## MEMORANDUM

**Subject:** Response to JART comments and follow up to Feb. 16, 2022 meeting.

This technical memorandum is intended to address remaining concerns expressed in the February 16, 2022 meeting with the JART hydrogeology technical team. The meeting was convened to address the following outstanding items related to the infiltration feature that will be constructed prior to Phase 3 excavation in the proposed West Quarry extension.

Figure 1: Simulated drawdowns in model Layer 6 due to (a) removal of the golf course irrigation ponds from the baseline conditions simulation and (b) removal of the infiltration feature from the P3456 conditions simulation.

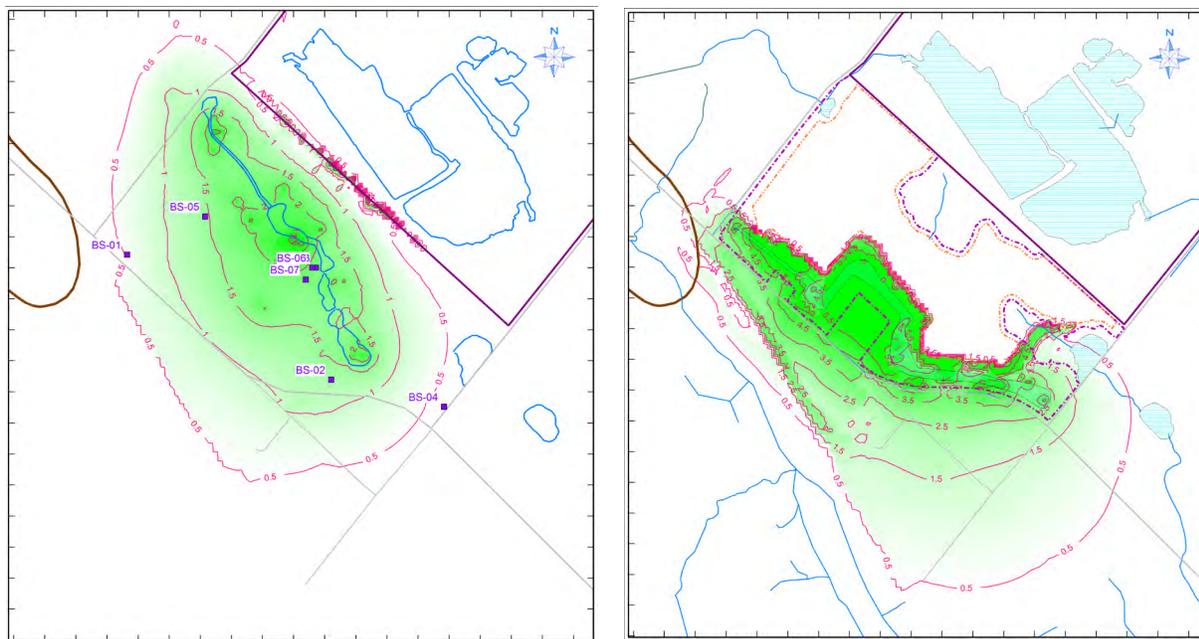
In the slide show, Earthfx presented results of two simulations conducted to isolate and quantify the effects of the golf course irrigation ponds and the infiltration feature. First, a model run was set up in which the golf course ponds were eliminated. Comparison of these results with the baseline conditions showed that infiltration from the golf course ponds accounted for about a 1.5

to 2.5 m increase in the water levels (Figure 1). Net seepage from the ponds was estimated at 130 m<sup>3</sup>/d (about 20 igpm).

A similar analysis was conducted with the infiltration ponds removed from the P3456 conditions simulation. Drawdowns show that the feature contributes to an increase of 4.5 to 5.5 m beneath the ponds and about 1.5 to 4.5 m along Cedar Springs Road. Net seepage from the feature was estimated at 780 m<sup>3</sup>/d (about 120 igpm). It should be noted that the infiltration ponds were simulated in a very conservative manner, assuming that the feature could clog over time due to runoff from the surrounding area and accumulation of organic material. The total suspended solids in the quarry discharge are low and would not contribute to clogging. Clogging would be prevented by periodic maintenance of the feature.

Figure 2: Simulated streamflow in Willoughby Creek upstream of SW7 with (blue) and without (red) the infiltration feature.

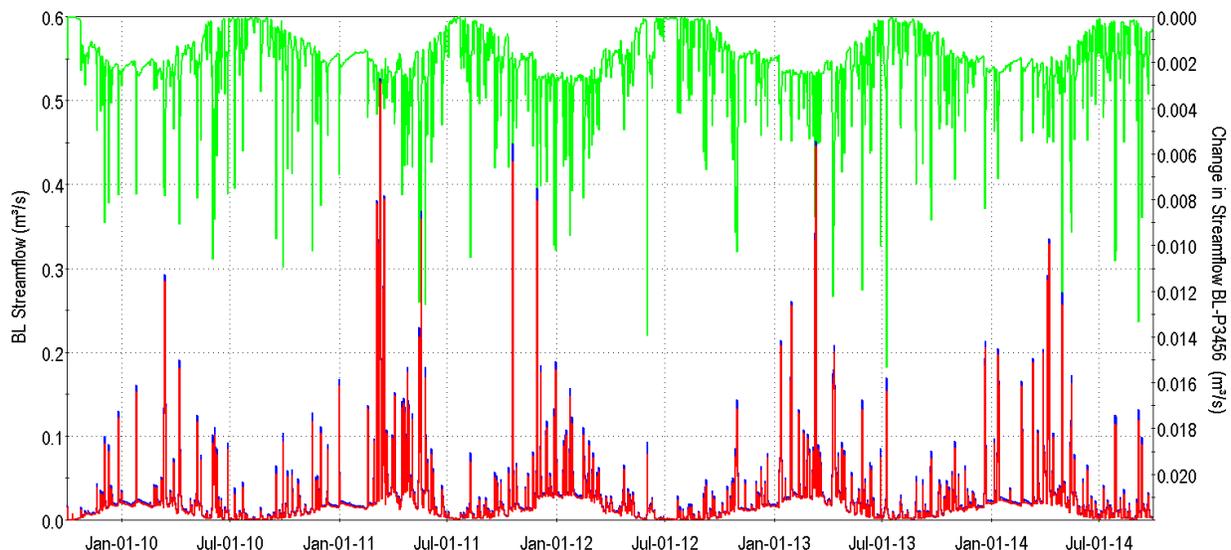
Earthfx presented a hydrograph of simulated streamflow in Willoughby Creek with and without the infiltration feature to address concerns related to impacts on groundwater-dependent habitat in the Medad Valley. The hydrograph shows that the decrease in baseflow in Willoughby Creek without the feature is very small (a decrease of about 0.002 L/s) and thus the feature has little influence on groundwater discharge. With regards to change in peak flows, the simulations indicated that there is some reduction in peak flows, but generally less than 0.01 L/s. Reductions in peak flows are generally considered beneficial as they tend to reduce potential for channel erosion. The changes here are insignificant.

Figure 3: Land surface elevation based on LIDAR data (no correction for tree cover).

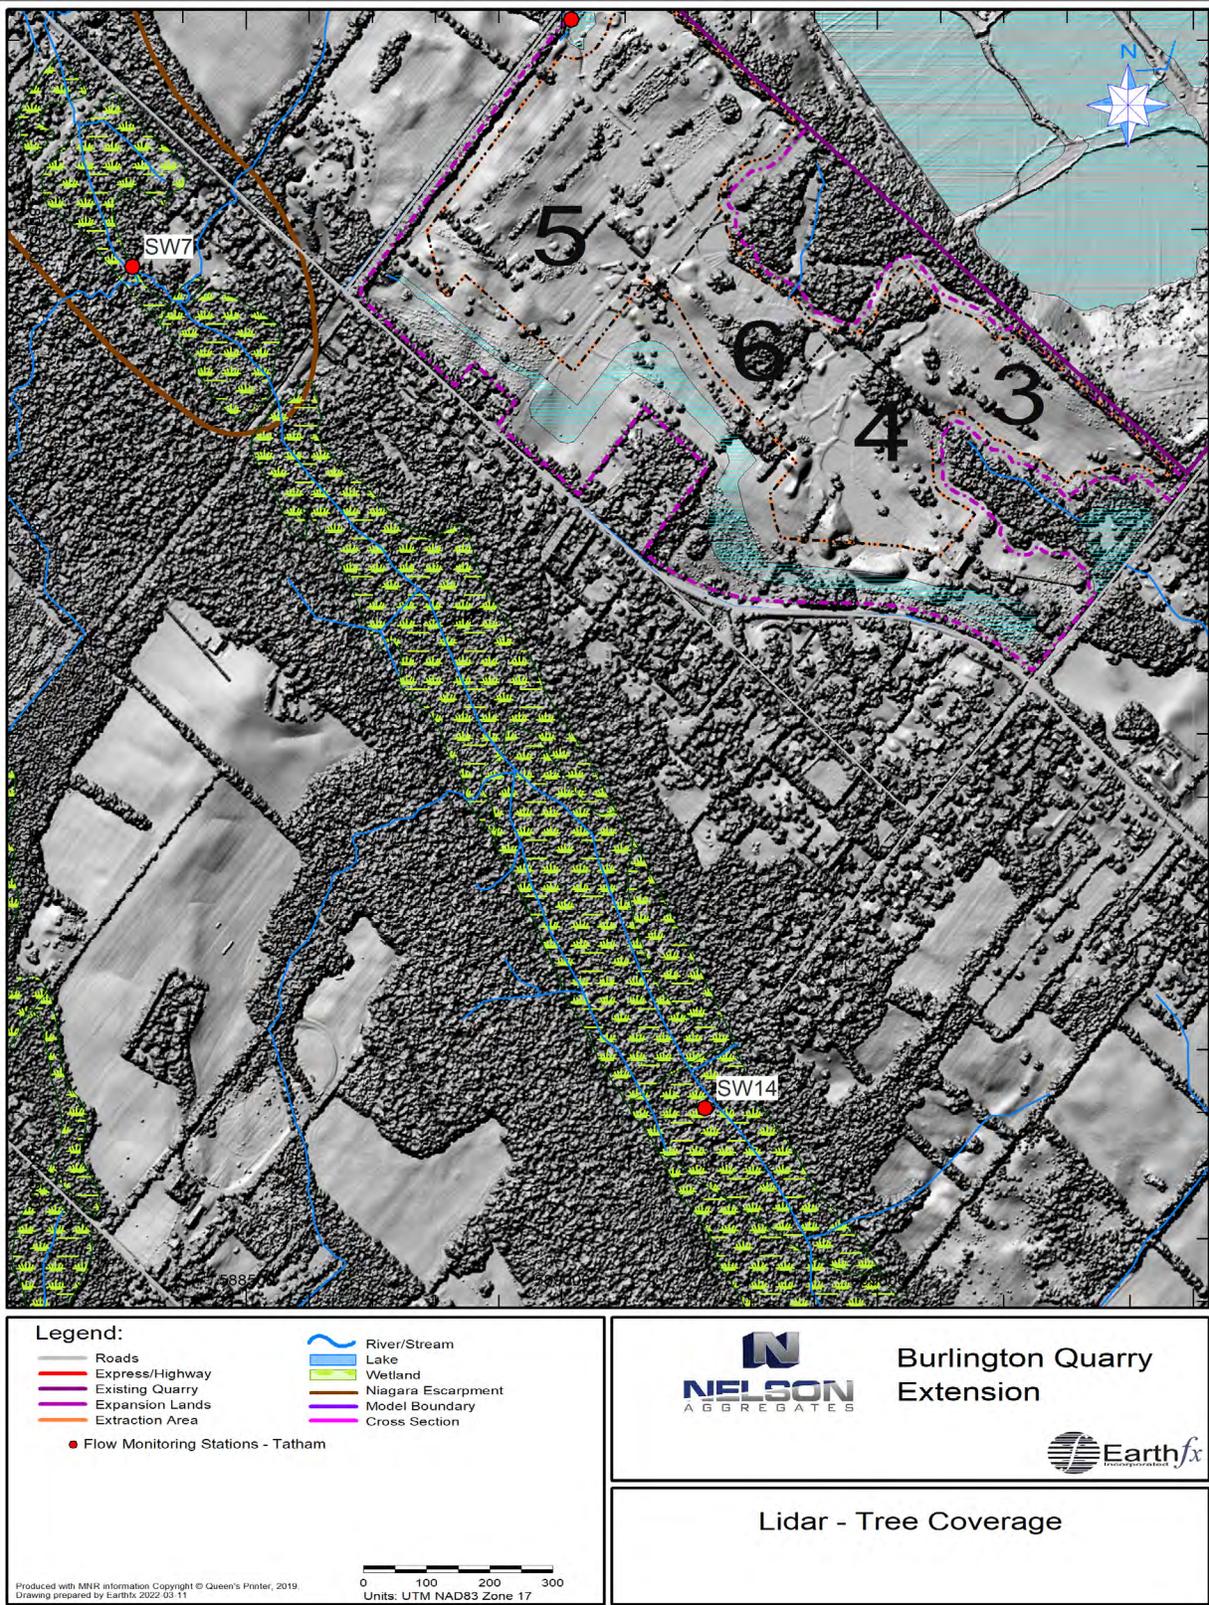
The LIDAR DSM (digital uppermost surface model, including treetops, Figure 3) shows that the tree canopy masks the wetland and stream channels configuration. The LIDAR DTM (digital terrain model, Figure 4), however, can see through the canopy to show the bare ground topography as extracted from the LIDAR point cloud data. This data clearly shows the steep walls of the valley and the exceptionally flat topography of the valley fill wetlands. No discernable channel features are visible in the flat wetland even in this high-resolution imagery (enlargement shown in Figure 5). The MNDMNRF "mapped" stream (blue line) is a series of straight-line segments, also reflecting the lack of a visible stream channel. This suggests that, in the absence of a defined stream channel, flow in Willoughby Creek may behave more like sheet flow than channel flow, due to the lack of an incised channel. Without an incised channel, most of the groundwater discharge will enter the wetland as surface leakage along the valley wall.

Figure 5: Medad Stream Network Mapping – Enlargement showing lack of defined stream channel

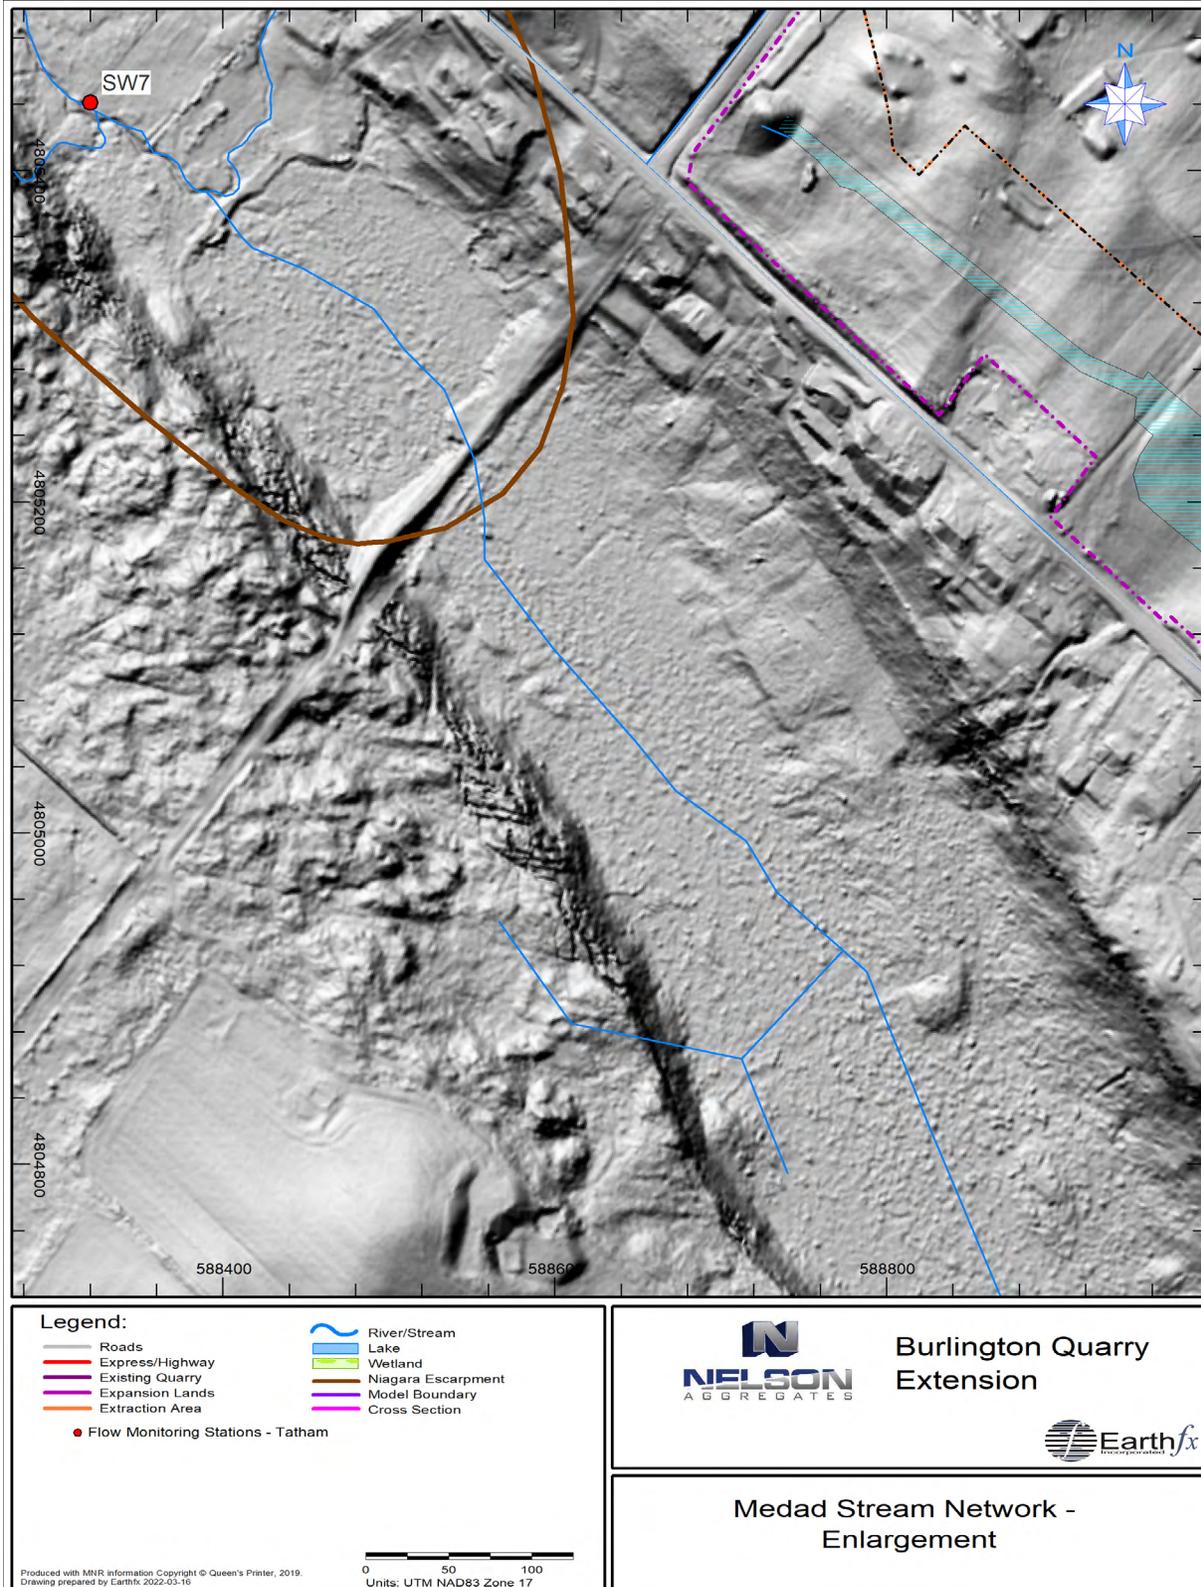
Figure 5, in particular, confirms that there are no discernible seeps and stream channels emanating from the east valley wall and joining Willoughby Creek.

Figure 6: Simulated average stream leakage and surface leakage in the Medad Valley under baseline conditions.

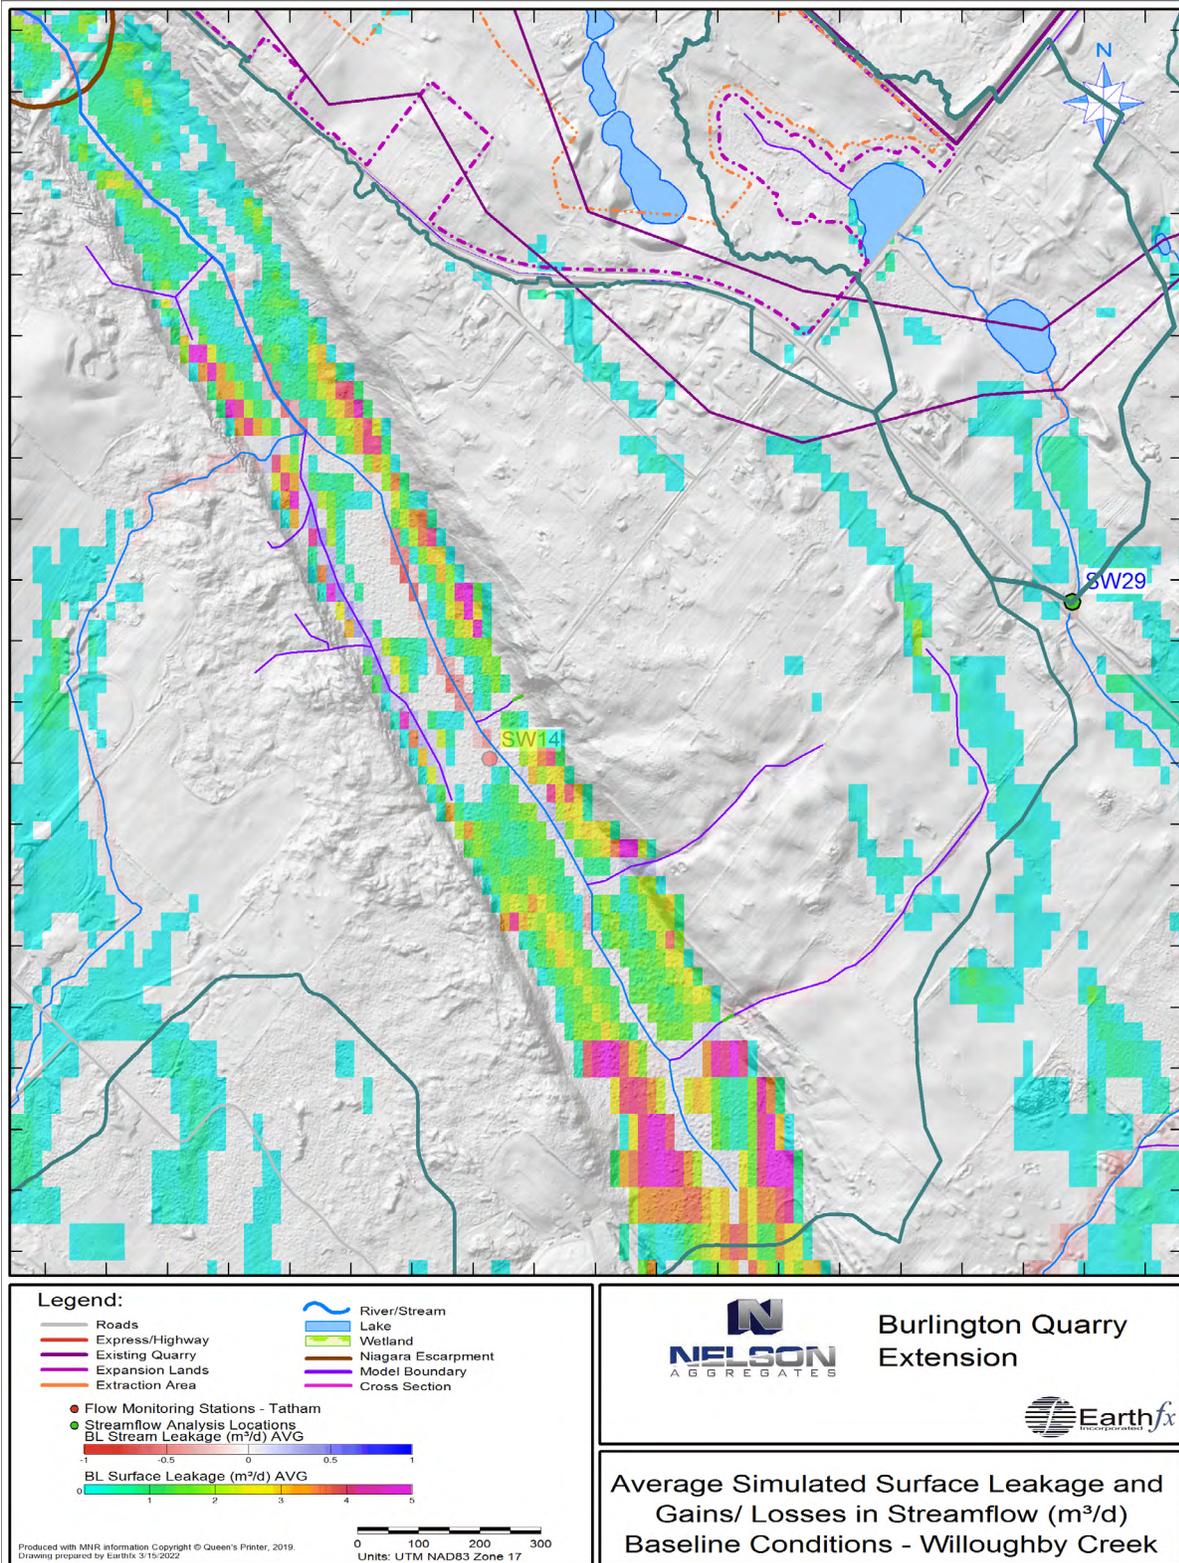
Figure 6 shows the average surface leakage in the Medad Valley vicinity under baseline (current) conditions. As can be seen, the highest rates occur in model cells adjacent to the valley walls on both sides of the valley. Pickup in streamflow (shown as blue shading along the stream lines) is relatively small and losses through the streambed occur in areas with larger influx of runoff related to surface leakage.

Figure 7: Change in groundwater discharge to the soil zone and predicted decrease in streamflow (Model results taken from Earthfx, 2020, Figure 8.70)

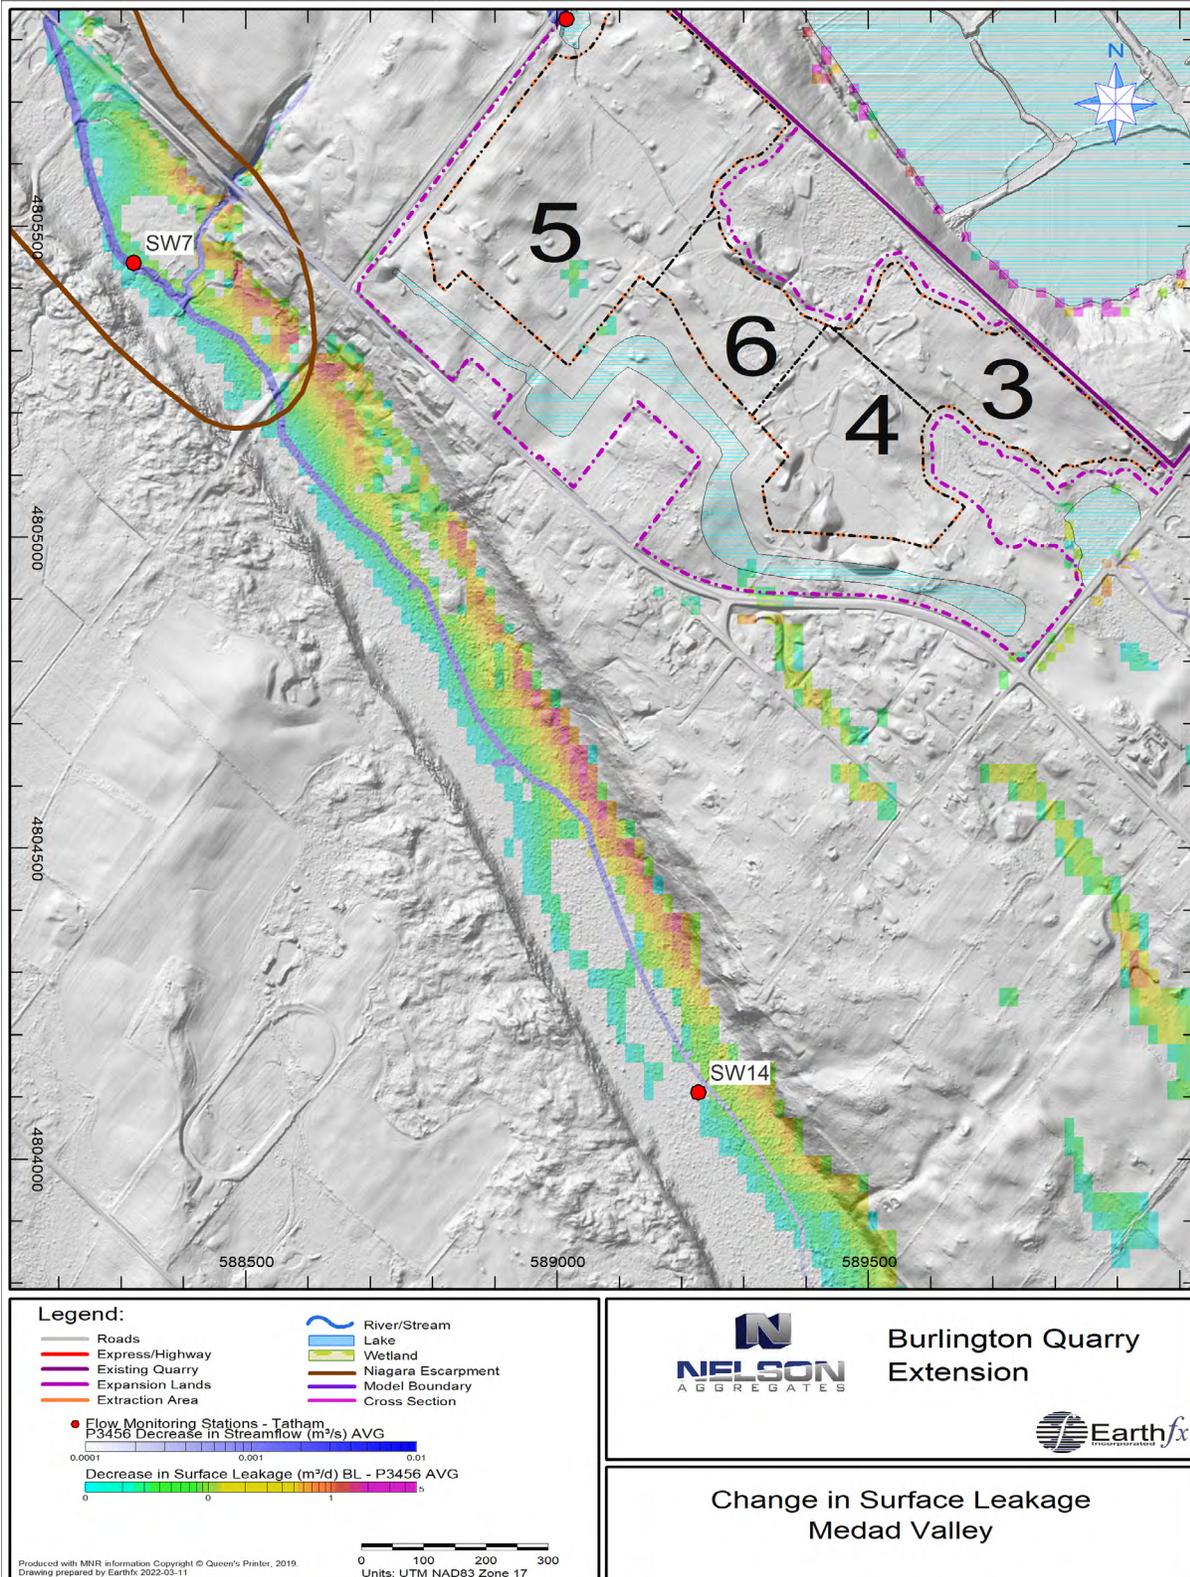
An overlay of the simulated *change in groundwater discharge* to the Medad valley (Figure 7) shows that the change in discharge between baseline and P3456 conditions occurs primarily along the eastern valley wall at the edge of the wetland (Note that the model results shown in Figure 7 were previously presented the Earthfx 2020 Level 1 / 2 Hydrogeologic Report, Figure 8.70).

In summary, the LIDAR data shows that there is no incised stream channel within the broad, flat wetland that fills the valley. This is consistent with the water budget that shows that the majority of the groundwater discharge to the Medad Valley enters along the edge of the wetlands as distributed surface leakage. The model results are consistent with the new LIDAR data, and shows that the modest change in groundwater discharge will occur in a distributed manner along the eastern edge of the valley.

Figure 8: Temperature profile at well BS07 before, during and after the pumping test at BS-06 (From Earthfx, 2020, Page 439)

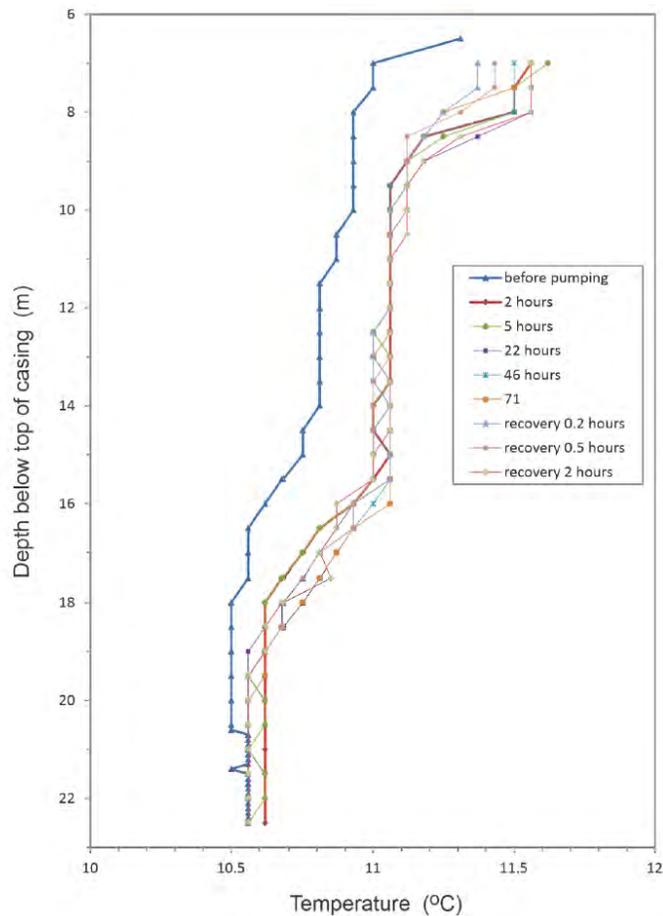
Most of the outstanding comments referred to in Item 4 (excluding Comment 6 and 231) questioned the assumption that the golf-course irrigation ponds are infiltrating water and that the infiltration feature will recharge the aquifer as designed. The lack of field data was cited in several of the comments.

Earthfx noted the leaky response observed during the BS-06 pump test as evidence of leakage from the nearby irrigation ponds. Further, we noted the temperature increase in the profile recorded in BS-07 before, during and after the pump test as strong evidence that surface water can leak downward and recharge into the aquifer system (Figure 8).
